Work Order ID 152818

Item Name: AS350/AS355 Quick Release Heli-Utility-Basket™ Long, Heavy Duty Lid

DART SERVICE INSTRUCTION

**TO AMEND INSTALLATION INSTRUCTIONS D350-607-3 Rev.D,
INSTALLATION INSTRUCTIONS D350-607-4 Rev. C AND
INSTRUCTIONS FOR CONTINUED AIRWORTHINESS ICA-D350-607 REV. 6**
REF TCCA STC: SH94-14
REF FAA STC: SR00213NY
REF EASA STC: EASA.10016996
REF BRAZILIAN STC: 2007S03-03/-04/-05/-06

FIGURE 1: INSTALLATION OF D4775-041 FWD STRUT

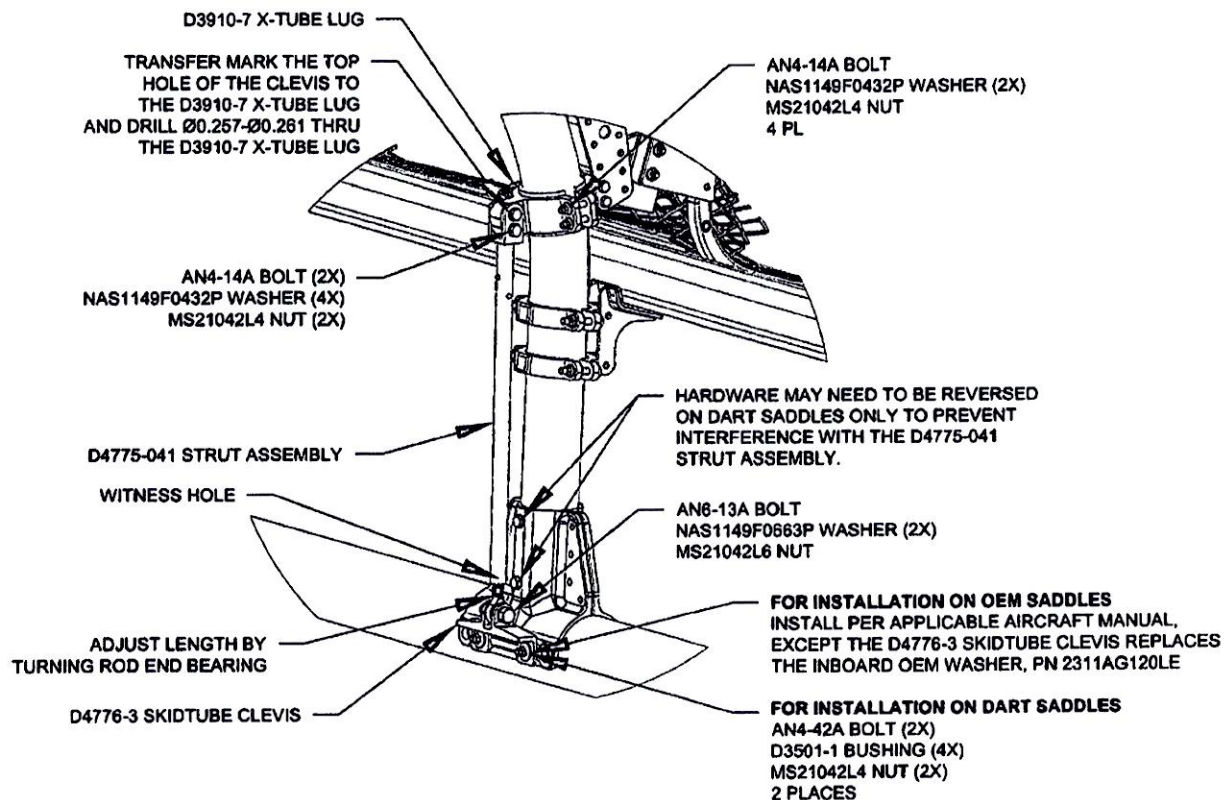
Install the D350-607-501 Conversion Kit, D350-607-511 Quick Release Mounting Kit or D350-607-431 Strut retrofit kit per Installation Instructions D350-607-3 Rev. D or D350-607-4 Rev. C. While installing the Forward Strut perform the following:

- 3.1 Substitute the Forward Lower D3910-5 X-Tube Lug with the D3910-7 X-Tube Lug as shown in Figure 1.
- 3.2 Install the forward D4775-041 Strut Assembly. Transfer mark from the upper hole on the clevis of the D4775-041 Strut Assembly to the D3910-7 X-tube Lug and drill thru the lug $\varnothing 0.257$ - $\varnothing 0.261$ as shown in Figure 1. Touch up chemical conversion coating per MIL-DTL-5541. Check the witness holes located at the bottom end of the D4775-041 Strut Assemblies to ensure that the thread from the rod end extends past the witness hole.
Torque MS21042L4/-4 nuts to 50-70 in-lbs (5.7-7.9 N-m). Torque MS21042L6/-6 nuts to 160-190 in-lbs (18.1-21.5 N-m).
- 3.3 Complete the installation in accordance with Installation Instructions D350-607-3 Rev. D or D350-607-4 Rev. C.
